## **SR 37** Transportation and Sea Level Rise Corridor Improvement Plan (Final)

June 2018

DRAFT CORRIDOR PLAN COMMENTS

We are writing to provide comments from the State Route (SR) 37 – Baylands Group on the *Draft SR 37 Transportation and Sea Level Rise Corridor Improvement Plan*, dated September 18, 2017.

**Exhibit 15: Existing Rail Facilities**

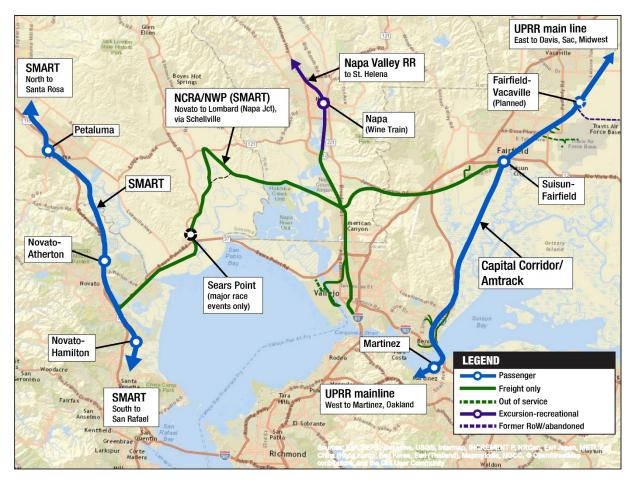
47	DAA Public Comment	Marin County, Department of Public Works	Page 16 - Exhibit 15. Sears Point/Infineon Raceway is north of SR 37; on this map the marker is south. And the train segmer labeled Amtrak only (not Capital Corridor).
48	DAA Public Comment	Marin County, Department of Public Works	Page 17 -Please provide details for costs shown in Table 2.
49	DAA Public Comment	Marin County, Department of Public Works	Page 18 - Item 2 should include the need for pump stations to move water, as gravity drainage may not work.
50	DAA Public Comment	Marin County, Department of Public Works	Page 19 -the embankment option will also likely require the need for pump stations to move water, because the roadway v as a levee.
51	DAA Public Comment	Marin County, Department of Public Works	Page 21 - Again, it would be helpful to show and describe the weak links in more detail.
52	DAA Public Comment	Marin County, Department of Public Works	Page 21- Table 3 reaches with "2050." What does that imply? The text implies the DAA will identify near-term roadway and improvements. What are the near-term design heights?

Comment noted. Exhibit 5 is intended to show the general locations of the weak links.	
wo lane road Comment noted.	
ent should be Graphic will be updated as appropriate.	
Preliminary cost estimates were included in the corridor plan, and may be refined in later project phases.

Exhibit 16: Schematics of representative Intersection operation improvements and lane merge improvements

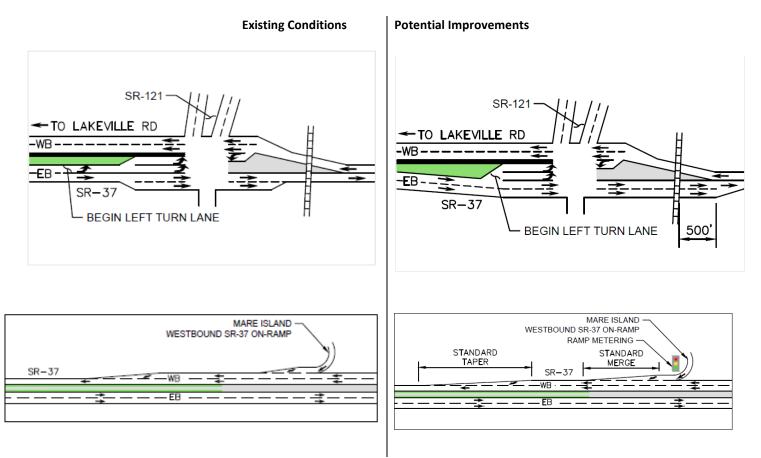
99 DAA Public Comment	Sonoma County Regional Parks	The "Potential Improvements" on Exhibit 16 (page 1 7) shows a proposal to increase the length of the eastbound right lane. The increased lane length would require widening of SR3 7 and could reduce the amount of land available to develop a proposed trailhead parking lot for the Bay Trail. Regional Parks is evaluating a trailhead parking lot at the southwest intersection of SR37 and railroad tracks.	Comment noted.		
100 DAA Public Comment	Sonoma County Regional Parks	Many of the concepts (pages 25-26) indicate use of a Class IV bikeway along the reconstructed SR37. Class IV bikeway is intended for the exclusive use by bicyclists and no pedestrians. These options would require construction of a separate exclusive facility for pedestrian use that is not currently indicated. Some of the options being considered in the Bay Trail - Sears Point Connector Feasibility Study, such as an elevated boardwalk or floating boardwalk crossing of Tolay Lagoon may be compatible with SR37 vehicle options and would provide a separate pedestrian and bicycle facility. We recommend at a minimum a Class I bicycle path with a physical barrier separating vehicle traffic on the south side of the roadway facing San Pablo Bay. This will allow trail users to enjoy and experience the views of San Pablo Bay and beyond.	The alternative included in the document are preliminary and include possible options for accommodating bicycles with roadway widening. They are not intended to preclude other alternatives that may be explored during later project development phases.
